GISBORNE HARBOUR-WORKS

(REPORT ON, BY MARINE ENGINEER, TOGETHER WITH COPIES OF DRAWINGS).

The MARINE ENGINEER, to the HON. the MINISTER HAVING CHARGE OF
THE MARINE DEPARTMENT.

Marine Engineer's Office, Wellington, December, 1890.

— WORKS COLOURED RED: VIDE SHEET, 2. —

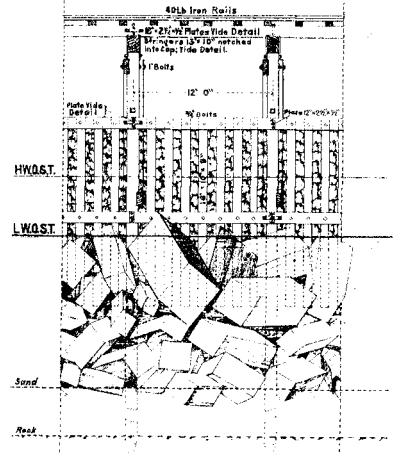
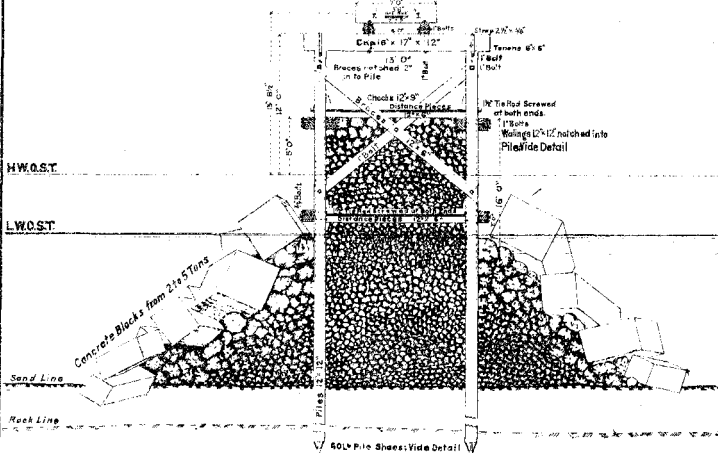
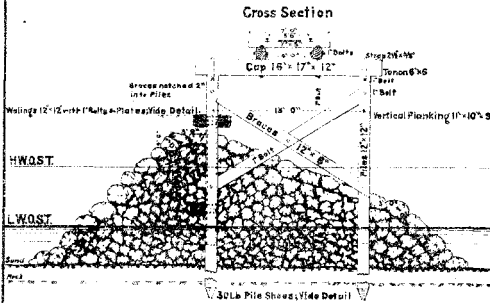
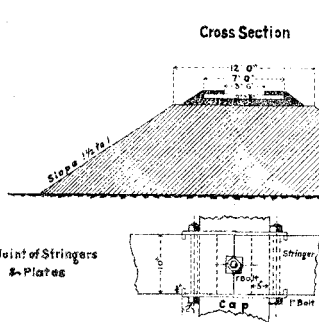
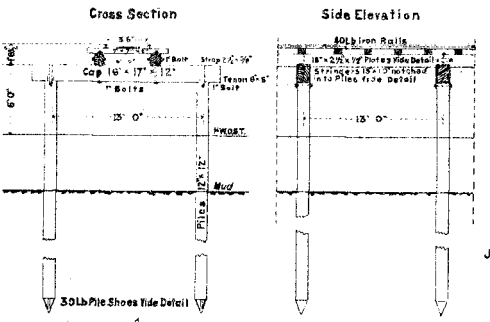
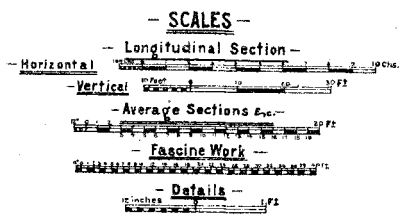
The small concrete blocks, indicated on drawing, are intended to be attained by blasting or splitting the concrete blocks now on hand, so far as they will go. After they are all used the balance required could be moulded to sizes indicated.

The underlying principle of the whole design is, of course, to get a wall on west side *projecting out beyond the shelter of the existing eastern mole*. I have assumed that a wall completely under the shelter of the existing work would do no good at all, as the sand would completely surround it, and still pile up against the existing mole as it does at present. *This is the great evil of the existing site, namely, that in order to get any useful result it involves two walls, the second of which must, for a considerable portion of its length, be nearly, if not quite, as strong as the first.* It is consequently a very expensive site to deal with, and hence, *inter alia*, my reason for saying above, that I could not recommend any extension of the existing works, as the cost would probably be excessive in view of the results which would be likely to be attained.

It is somewhat doubtful if the extreme outer portion of the work as designed is quite strong enough. If not, it will have to be supplemented with further concrete blocks. This is not directly provided for in estimate, but would probably be covered by the £2,000 included for contingencies.

For a distance of 726ft., from A to B, at outer end, the work consists of a timber viaduct, spans 12ft. centres, with cribwork at both sides, and having filling and slopes of rubble, protected at both sides by concrete blocks of from 2 to 5 tons each.

The next 460ft., B to C, consists of a similar timber viaduct, but with cribwork at one side only, and rubble mound without concrete facing.

The next 218ft., C to D, has been designed for the present as a timber viaduct only, spans 12ft. centres. No special form of filling is indicated, as it is hoped that such filling-in as may be required, may be done with fascines or rough timber work of some very inexpensive character.

The next 363ft., D to E, which is intended to terminate at edge of present sand-cliff, above high-water mark, is a sand-embankment, faced on both sides with fascines, and sufficient rubble stone to protect the sand from the wash of the sea.
